CORRECTIONS AND CLARIFICATIONS TO VM0042 METHODOLOGY FOR IMPROVED AGRICULTURAL LAND MANAGEMENT, V2.0

Publication date: 22 January 2024

Updated: 14 March 2024

Figure 1: Examples of defined quantification units and strata

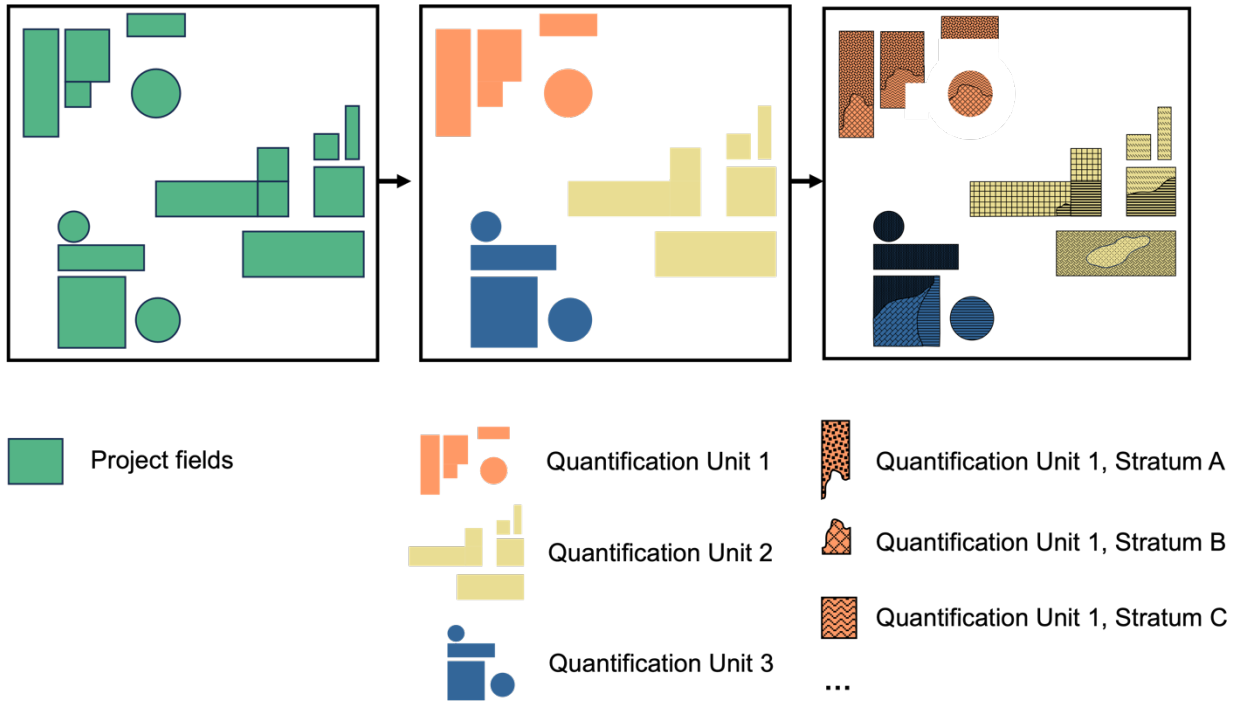
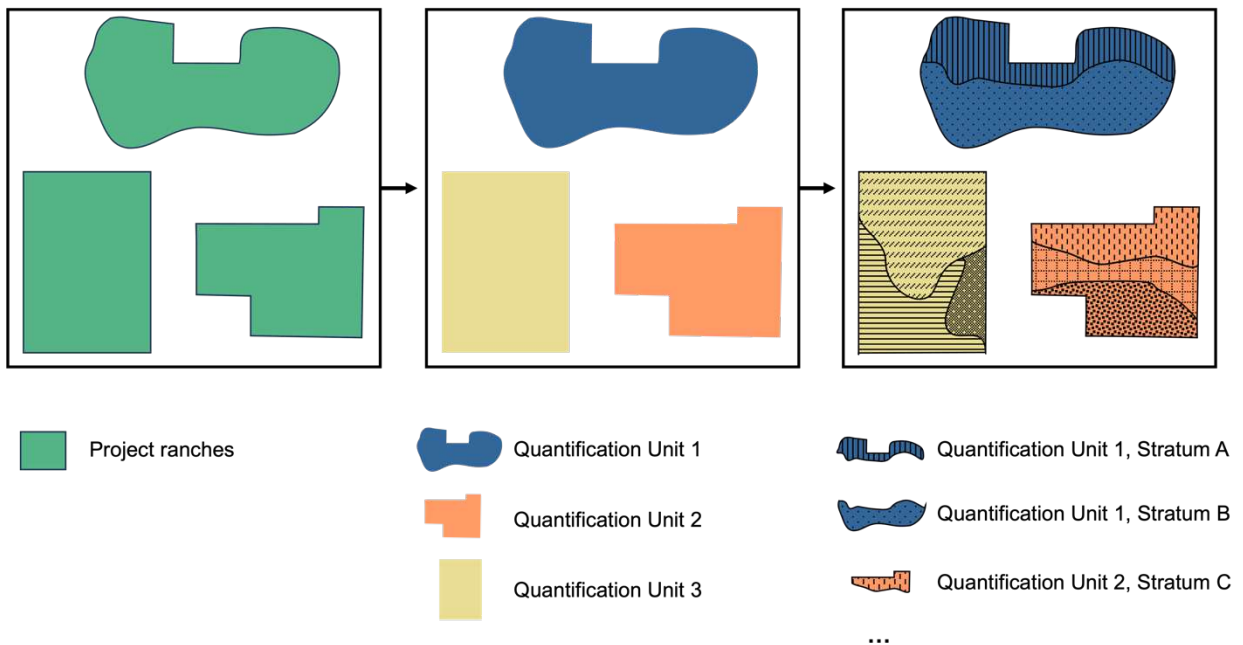
Figure 2 shows two examples of defining quantification units and strata. Random samples should be taken in each stratum.

Enhance clarity around the two terms “Quantification unit” (previously “Sample unit”) and “Stratum,” which are essential for designing sampling and quantification strategies as part of project monitoring, reporting and verification (MRV).

Soil sampling must be conducted following the stratified random sampling strategy.²⁷ Each quantification unit within the project area should be divided into **homogenous strata sub-units (i.e., strata)** based on factors influencing SOC stock distribution (see below) that **make each stratum more homogenous than the project area in its entirety.**

Each quantification unit within the project area must be divided into homogenous strata based on factors influencing SOC stock distribution. In a staged (i.e., hierarchical, nested) design, strata should be generated at the lowest level of quantification unit (see Appendix 6 for an example). Thus, if a sampling design establishes primary and secondary quantification units, strata should be generated as a subset of each secondary quantification unit. The aim of stratifying each quantification unit is to capture SOC stock variability more accurately. Depending on the size of the agricultural fields or paddocks, strata may span numerous fields/paddocks, or one field/paddock may be divided into several strata.

Summary

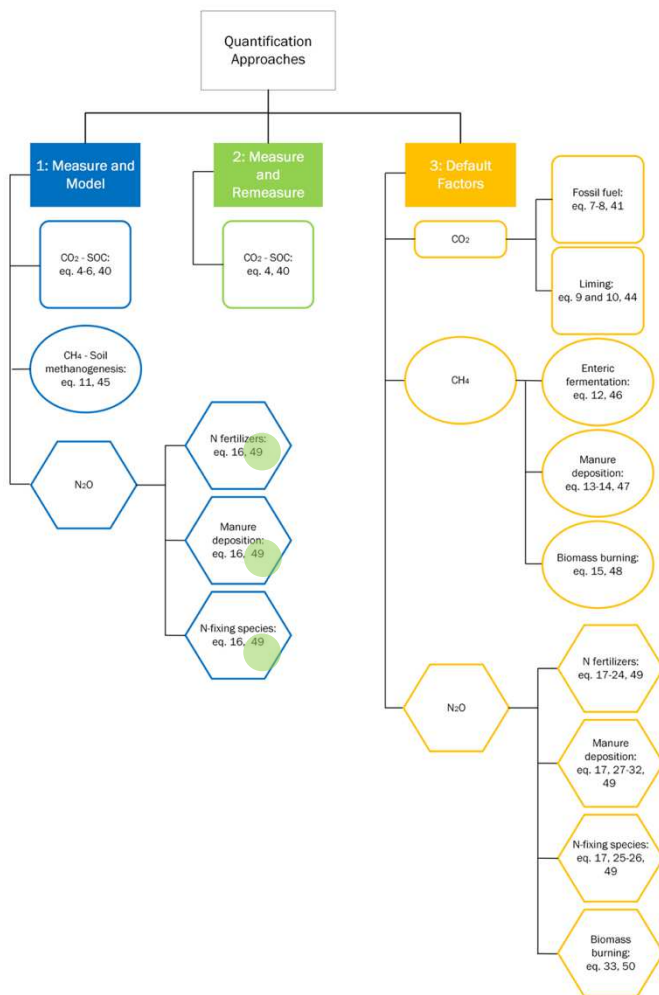
Added subsection title “Summary” for greater clarity on the section’s structure and corrected reference to Equation 49 for N₂O emissions following Quantification Approach 1 in Figure 1.

Figure 1 summarizes which equations are to be applied to each GHG flux depending on the selected quantification approach (see also Table 5).
